NUMBER: 18-021-05

THIS BULLETIN SUPERSEDES TECHNICAL SERVICE BULLETIN 18-035-04 REV. A, DATED NOVEMBER 18, 2004, WHICH SHOULD BE REMOVED FROM YOUR FILES. ALL REVISIONS ARE HIGHLIGHTED WITH **ASTERISKS**** AND INCLUDE AN ADDITIONAL ENGINE.**

Flash: MIL Illumination With Diagnostic Trouble Code P0339

Fig. 1 AUTHORIZED MODIFICATION LABEL

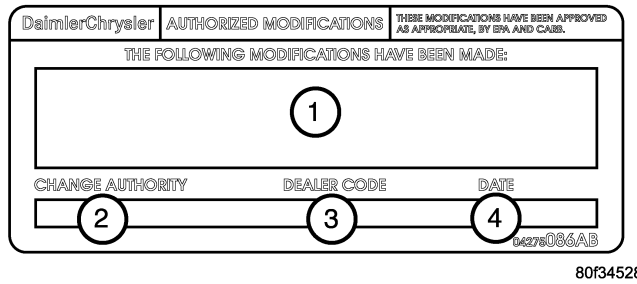
13. Type the necessary information on the "Authorized Modification Label" p/n 04275086AB and attach near the VECI label ([Fig. 1](#)).
